SUBJECT: RETRANSMITTAL OF WESTINGHOUSE RESPONSE TO NRC REQUESTS  
FOR ADDITIONAL INFORMATION ON THE NOTRUMP COMPUTER CODE

## NRC REQUEST FOR ADDITIONAL INFORMATION

Re: WCAP-14206 (NOTRUMP CAD)

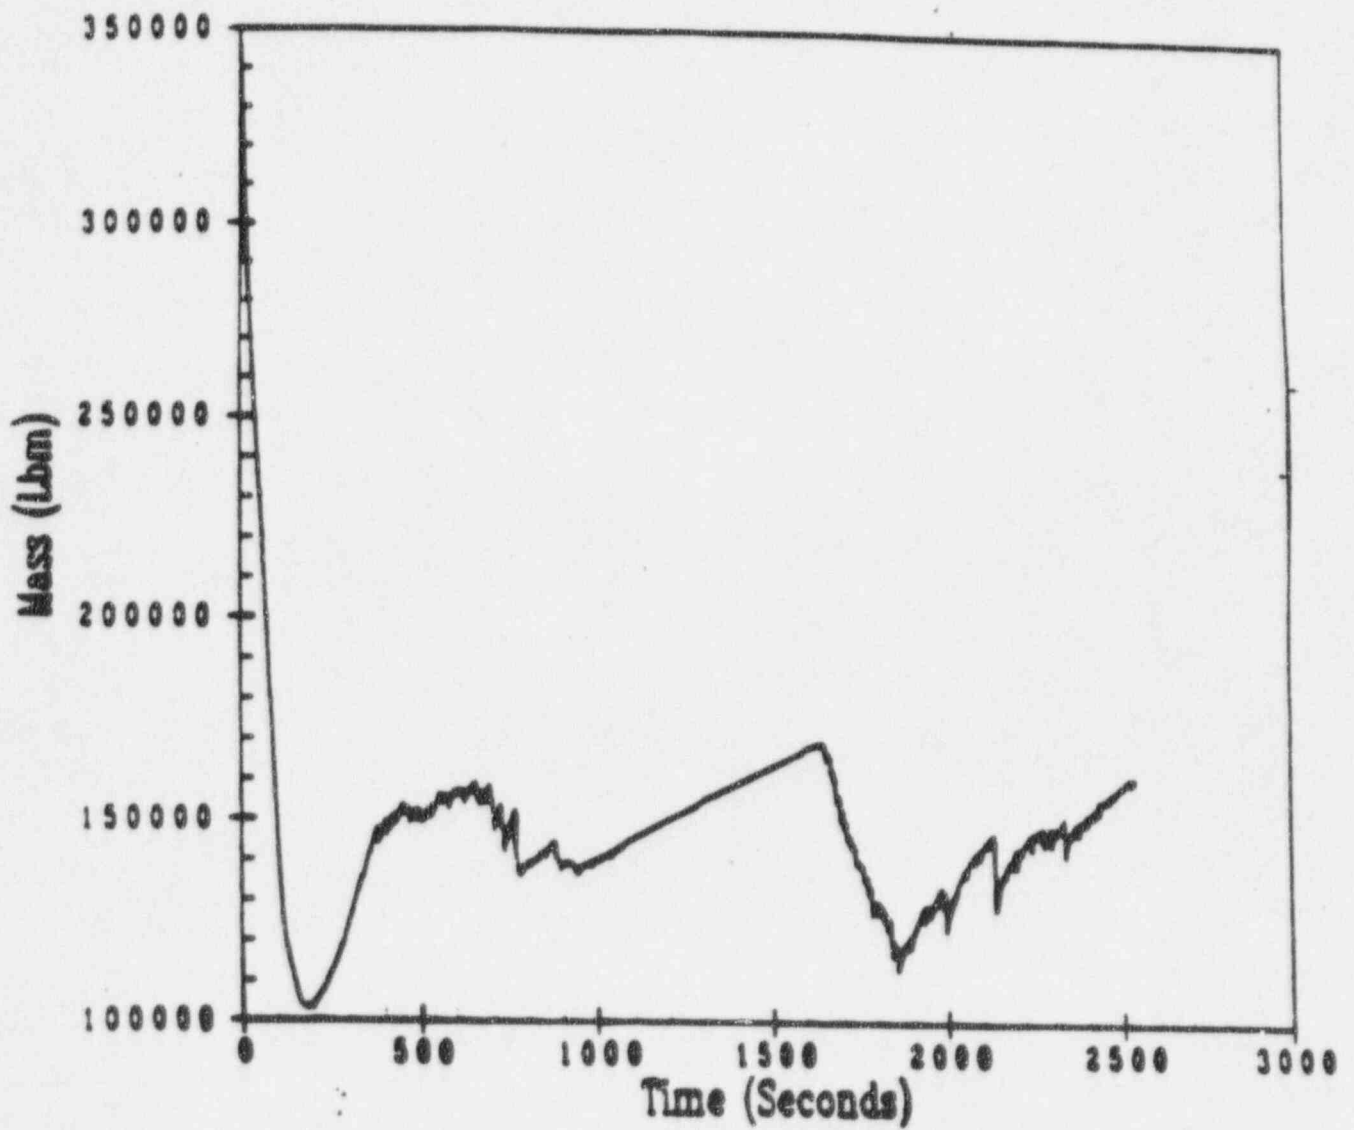
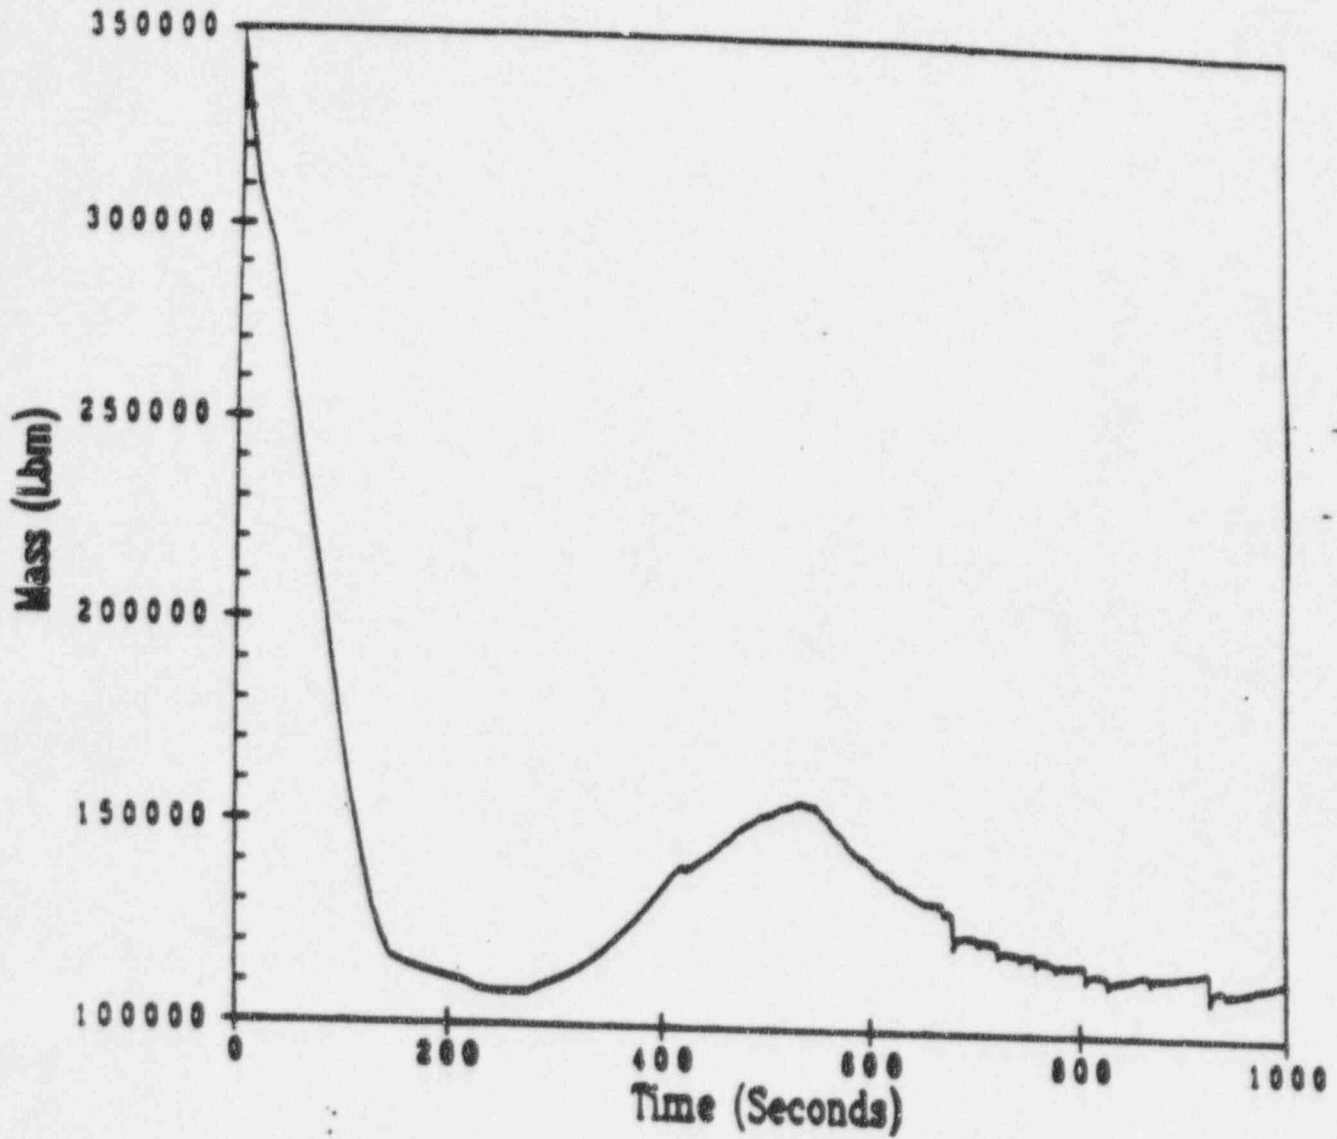
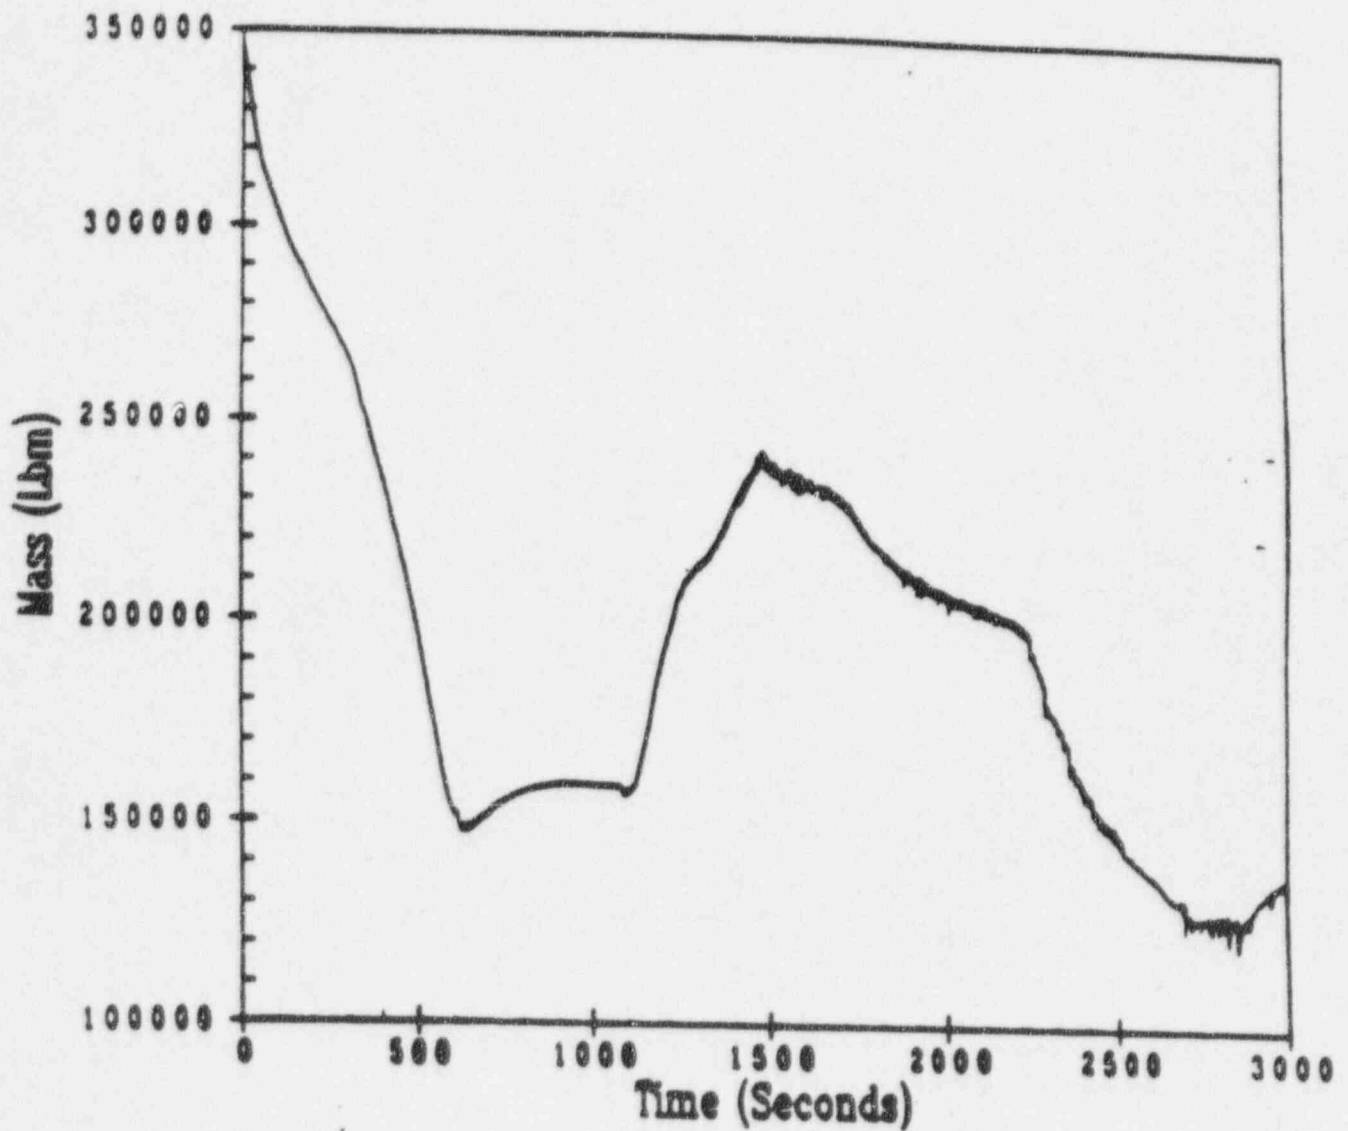
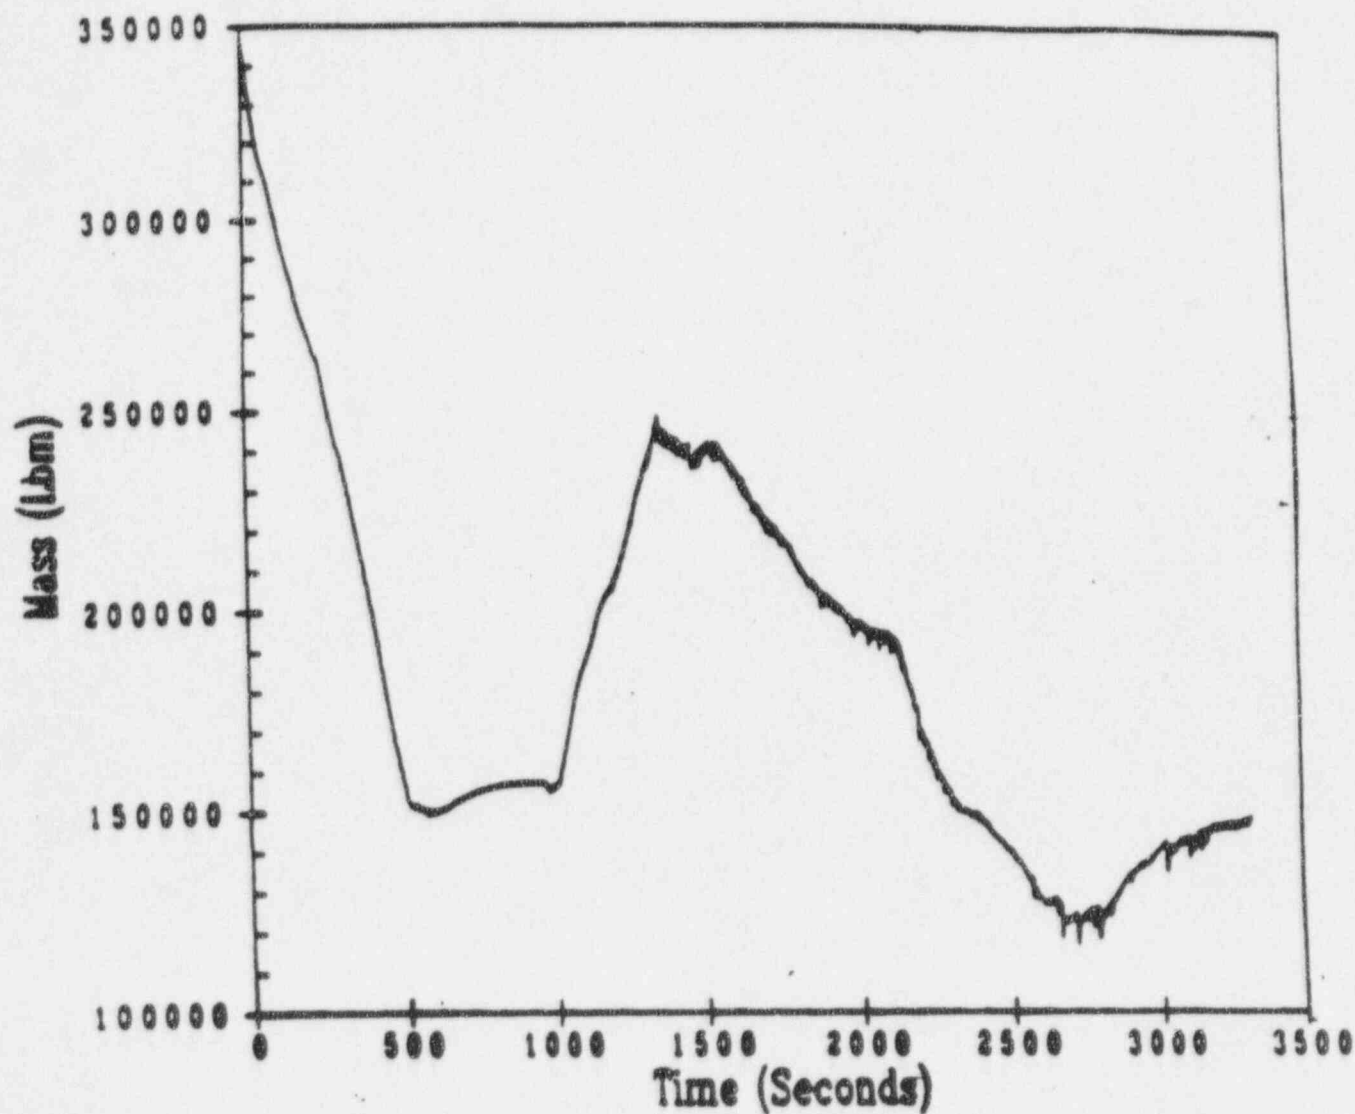
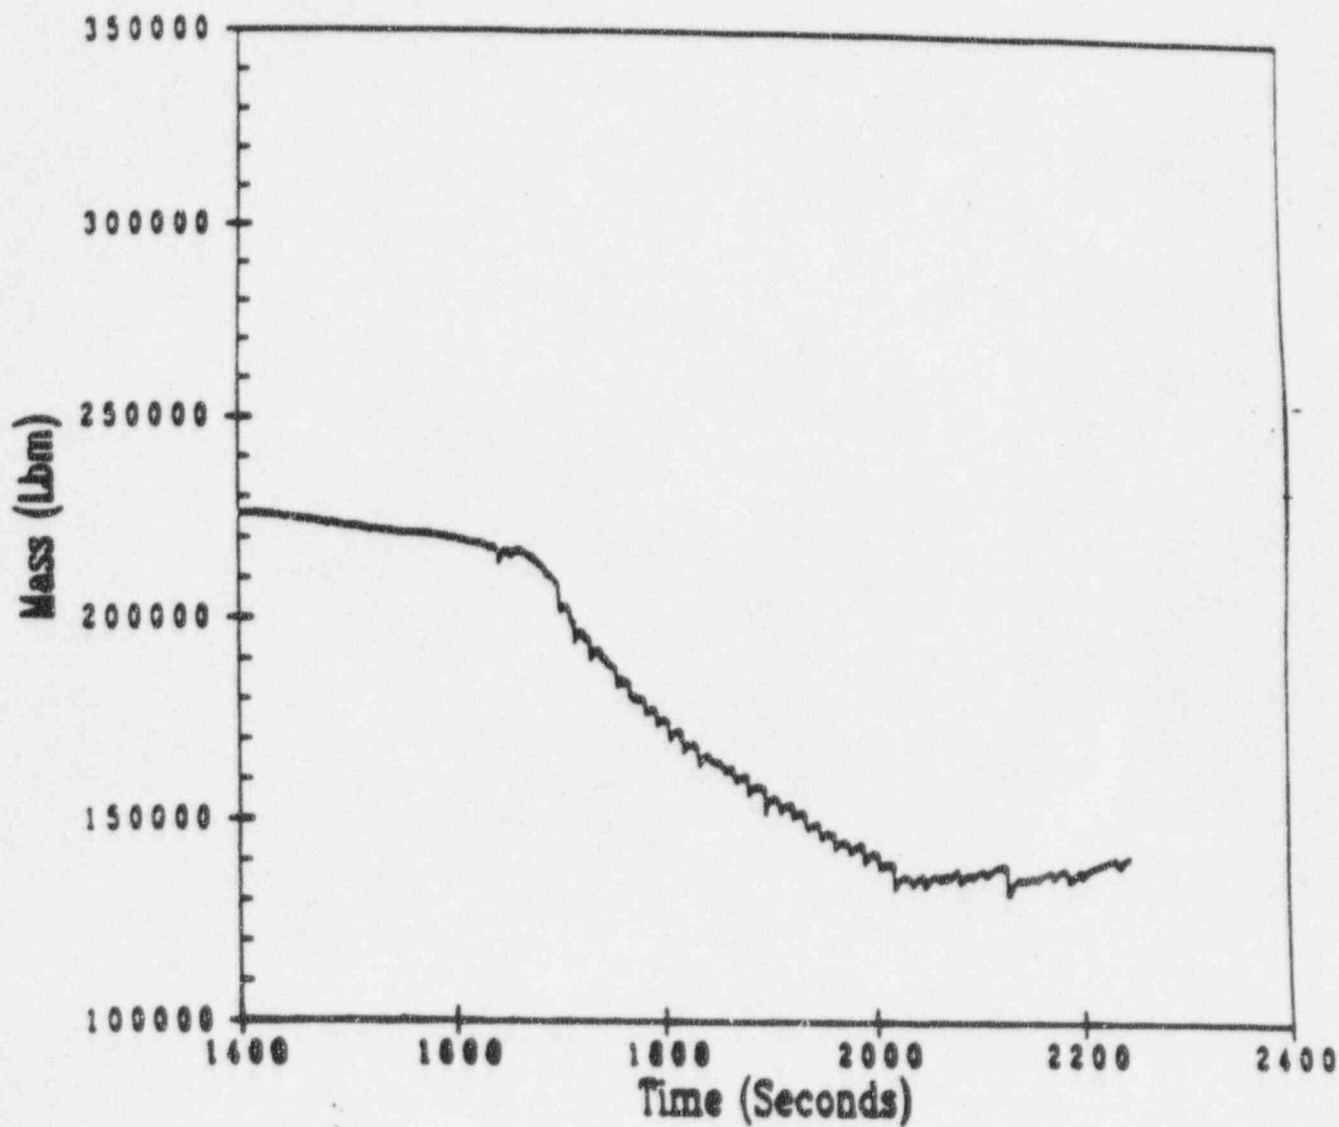
On page 2-5 the limiting failure is a failure of one fourth-stage ADS. Please explain what analyses were performed supporting this conclusion. Also, in view of changes to the ADS, is this still a valid statement? Please explain or provide new information for the limiting failure.

The limiting single active failure in an AP600 small break LOCA analysis depends on the postulated break size and location. In the Reference 440.328-1 break spectrum, the failure of a single fourth-stage ADS valve was modeled in the inadvertent ADS actuation and two-inch cold leg break cases. However, for the double-ended direct vessel injection line break and the double-ended balance line break the postulated failure that renders a single first-stage and a single third-stage ADS valve unavailable is limiting.

The AP600 passive safeguards systems are designed such that no single active failure in either the safety injection or PRHR heat exchanger loops can deprive the reactor of a core makeup tank, accumulator, IRWST or PRHR delivery path. Only failures within the ADS can eliminate safety-related path(s) which otherwise would be in operation during a small break LOCA event. Among the small break LOCAs, the time in the event at which the minimum reactor coolant system mass inventory occurs determines which postulated ADS failure is more limiting. As shown in the attached Figures 440.328-1 and 2, both of the double-ended breaks from Reference 440.328-1 exhibit their minimum RCS mass inventories early in the transient, at about the time at which ADS stage one is activated. Recovery from this minimum mass condition is accomplished via accumulator injection; therefore, if failure of an ADS stage one valve can delay the time at which fully effective accumulator flow is achieved, the minimum RCS mass will be adversely affected for these larger small breaks. Furthermore, the break itself is large enough in these cases to constitute a significant vent path which augments the ADS paths; the degradation in venting associated with the failure of a fourth stage ADS valve is less important in the depressurization of the reactor to achieve IRWST injection. A sensitivity case verified that the postulated stage one/three valve failure is indeed limiting for the AP600 double-ended rupture small break LOCA cases.

In contrast, two-inch cold leg break and inadvertent ADS actuation transients in Reference 440.328-1 exhibit minimum mass inventories (Figures 440.328-3 through 5) when IRWST injection begins. Because depressurizing the reactor to the point at which IRWST injection begins is totally dependent on ADS capability for the smaller small break LOCAs, the postulated failure of one of the largest ADS valves present, a fourth-stage ADS valve, is limiting. Prior to fourth-stage ADS actuation, each of these cases reaches a quasi-equilibrium pressure value which is almost independent of whether a single failure exists among the ADS stage one/two/three valves.
